802.1CB-2017/Cor1

Editor's update

Christophe Mangin

2024/7/16

Figure 6-y—Internal LAN: array of upper SAPs

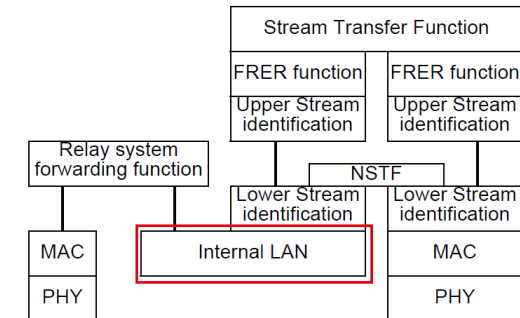
- An in-facing Stream Identification Function will currently discard the stream_handle subparameter upon output towards the Internal LAN (6.4, 6.5, 6.7, 6.8). Even if no in-facing Stream Identification Function is configured, section 6.2 implies the stream_handle subparameter is not passed towards the Internal LAN upon output. This prevents the stream_handle subparameter to be available for the Per-stream classification and metering ([Q]:8.6.5.2).

- Remove the sentence “It discards the stream_handle subparameter passed down the stack” in 6.4, 6.5, 6.7, 6.8 (passive Stream identification functions)
 - Add a new sub-clause (6.x) describing the Internal LAN and the Forwarding functions

“The Internal LAN models a fully transparent frame transfer function along with all (Enhanced) Internal Sublayer Service (E/ISS) parameters.”

- Stream_handle “loss” in an ingress port along the path towards the bridge forwarding functions
 - Editor’s proposal
 - Keep consistency with existing text of 6.3 already introducing the (N)STF
 - No additional sub-clause for the definition of the Internal LAN
 - Include the following text in the 2nd paragraph of 6.3 after « ... in order to enable an FRER function ».
 - « The connectivity between the Relay system’s forwarding and the Stream identification functions is modelled by an Internal LAN that provides transparent connectivity between ISS, or EISS, SAPs supporting the Stream service subparameters (6.1). »
 - Remove the sentence “It discards the stream_handle subparameter passed down the stack” in 6.4, 6.5, 6.7, 6.8
 - Any other changes required ?

b. Relay system with separated FRER capability, e.g., packet counting, on an output port.

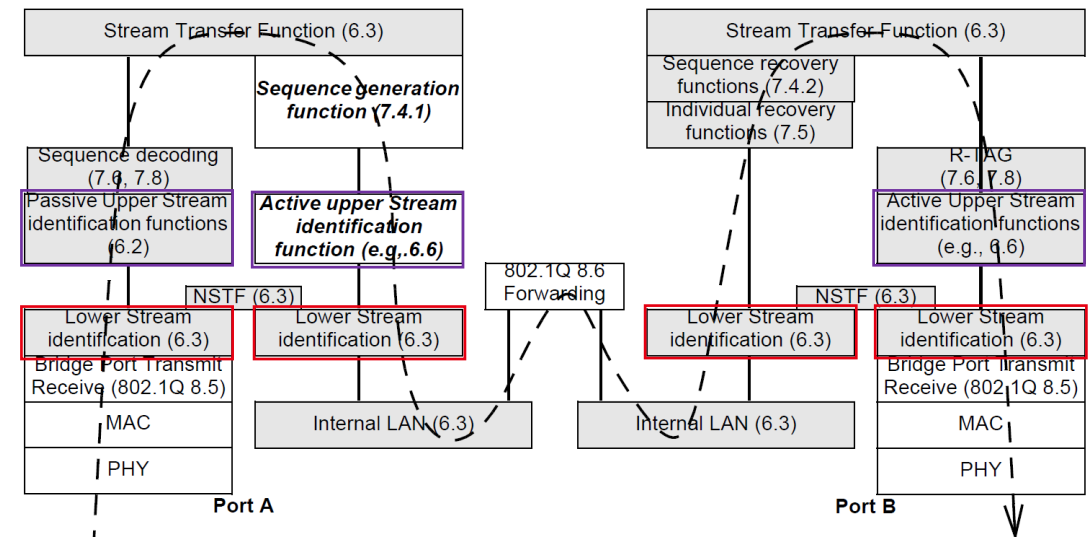
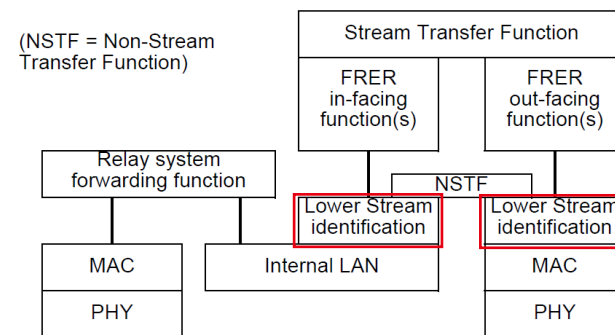
- Figures 6-5, 6-6, and 8-1 show a Lower and an Upper Stream identification function: "The Lower Stream identification functions separate FRER packets from non-FRER packets; the latter are relayed across the NSTF as if the FRER capabilities were not present. The Upper Stream identification functions identify the FRER packets' Streams ..." (6.3), while Figure 6-4 shows a single identification block with upper layer SAPs for the different stream_handles and the NSTF ("Packets belonging to no Stream, or to a Stream unknown to this Stream identification function").
The task to "separate FRER packets from non-FRER packets" (6.3) is impossible to achieve, as only the match to a Stream Identification function constitutes the Frame to have to be processed by further FRER functionality up the stack.

Figure 6-4—Stream identification function: array of upper SAPs

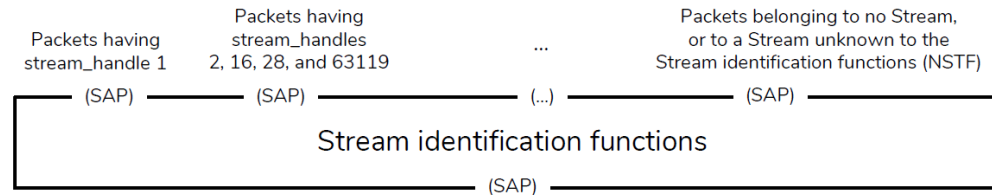
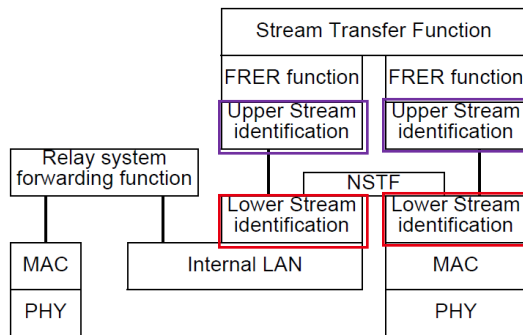
The "Lower/Upper Stream identification function" terminology should be removed from 6.3 and Figure 6-3 deleted.

- Changes to figures in 6.2

~~Figure 6-3—Stream identification function: single upper SAP~~

Delete Figure 6-3

Modify Figure 6-4

Figure 6-4—Stream identification functions

b. Relay system with separated FRER capability, e.g., packet counting, on an output port.

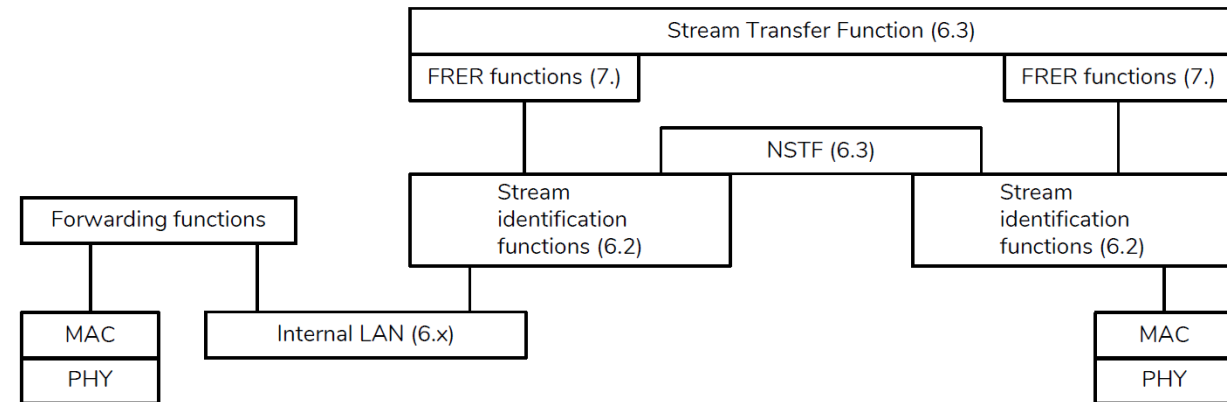
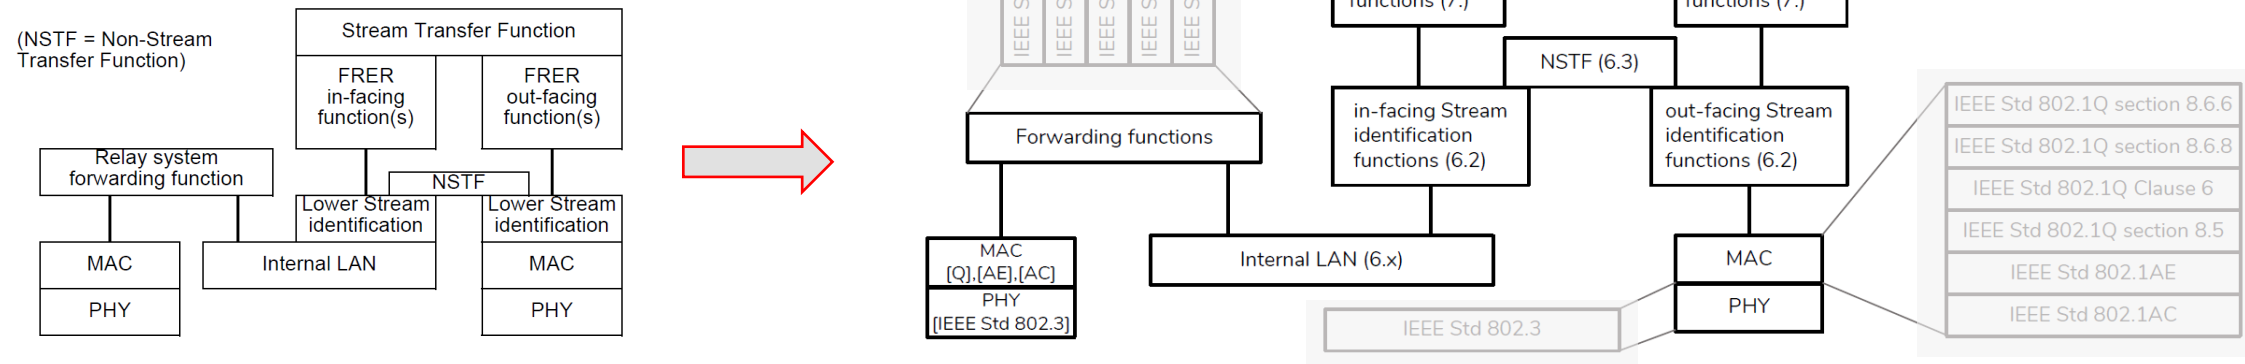
- Introduction of “Lower” and “Upper” Stream identification functions
 - Initial proposed resolution
 - Changes to figures in 6.5b

- Changes to figures in 8-1

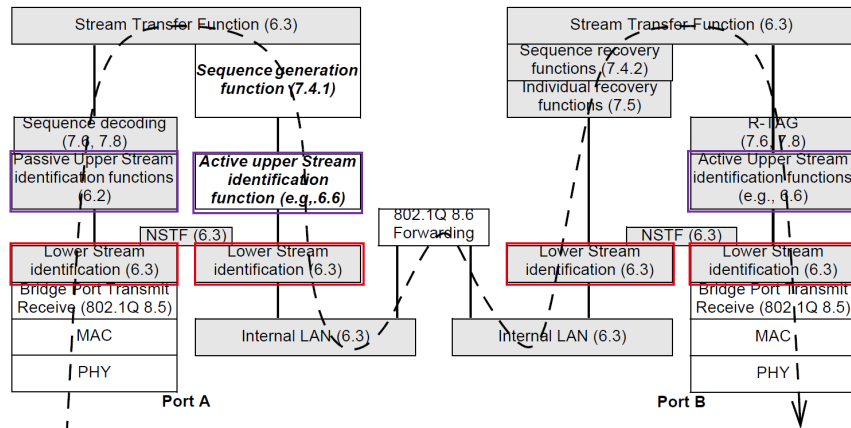
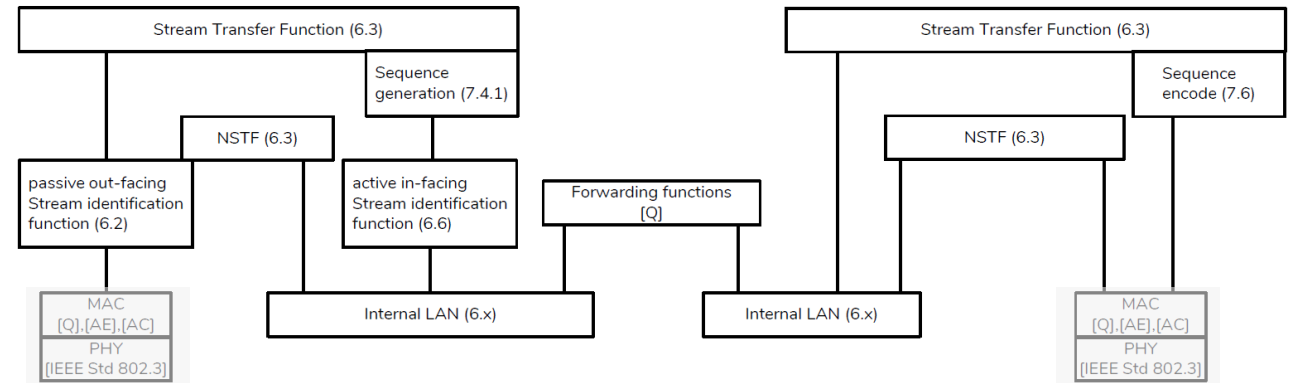
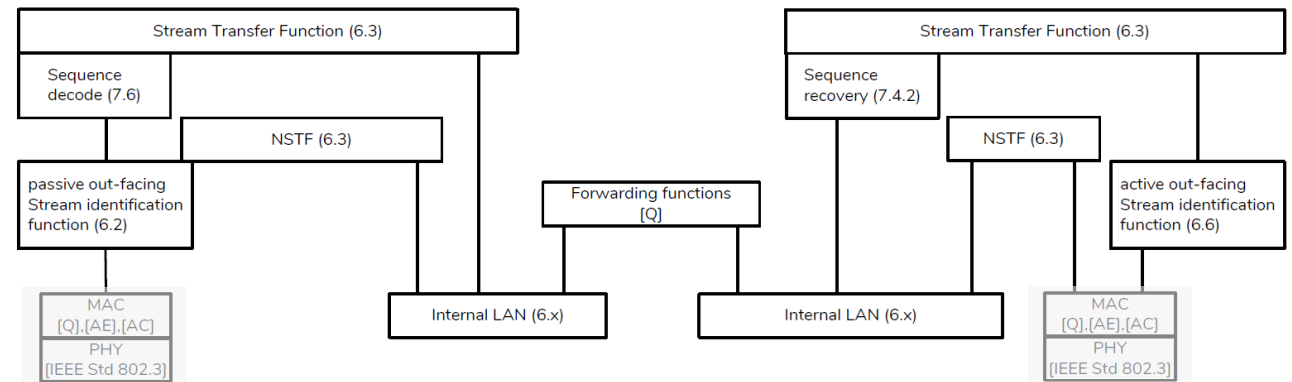
- Introduction of "Lower" and "Upper" Stream identification functions
 - Initial proposed resolution
 - Changes to figures in 6.6

- Introduction of "Lower" and "Upper" Stream identification functions

- Initial proposed resolution

Proposed Fig. 6-6

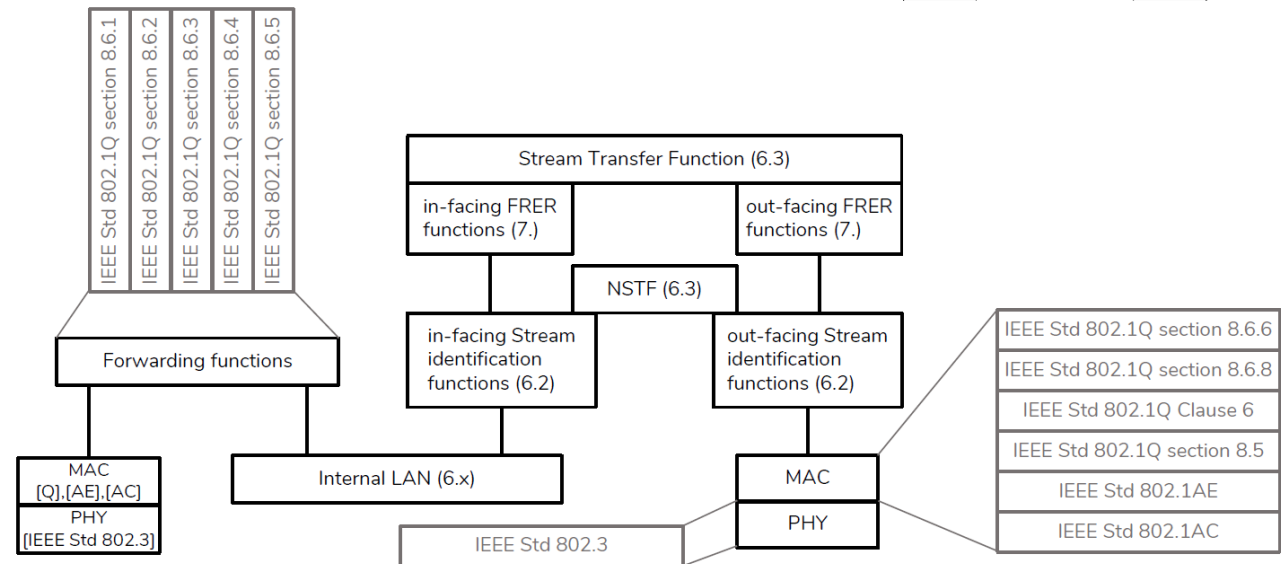
- Section 8.1 j) “... take place after all forwarding (except Queuing frames, 8.6.6 of IEEE Std 802.1Q-2014)” and Figure 8-2 contradict Figures 6-5, 6-6, 8-1, C-5, C-6, C-7, and C-12, as the later all show or imply ALL functionality of [Q]:8.6 to be encompassed by the “(Relay system) Forwarding function”.

Since 8.1 j) and Figure 8-2 have been determined to be correct, the other figures need to be adapted accordingly.

- Proposed changes in Fig. C-5,6,7,10,12 consist in introducing Q 8.6.6, 8.6.8, 6, 8.5, AE and AC in the MAC of the port including the Stream identification and FRER function

- Detailed in the proposed modifications of Fig. 6-6

Figure 8-2—Augmented Forwarding Process does sequence recovery

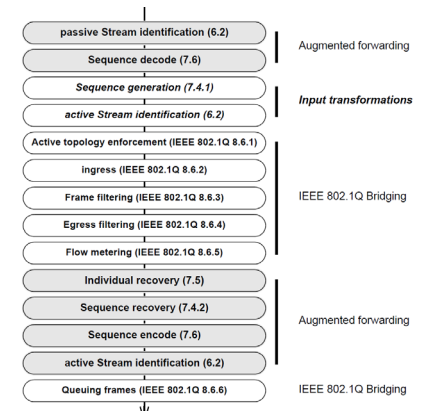
- The layered model is there to permit the introduction of FRER in ports of a relay system, which forwarding function does not support any of the FRER functions, including Stream identification.
- Figure 8.2 illustrates a way to integrate the FRER functions with the forwarding functions of a bridge
 - Not the same architecture (as the layered model), more a detailed view of Fig. 6-5 a)

- Part of the forwarding functions should not be « moved » to the MAC (as shown below)

- Question: have the « upper » and « lower » Stream identification functions been introduced as a mean to mux/demux Streams/non-Streams, and especially to multiplex Streams and non-Streams towards the port’s MAC ?
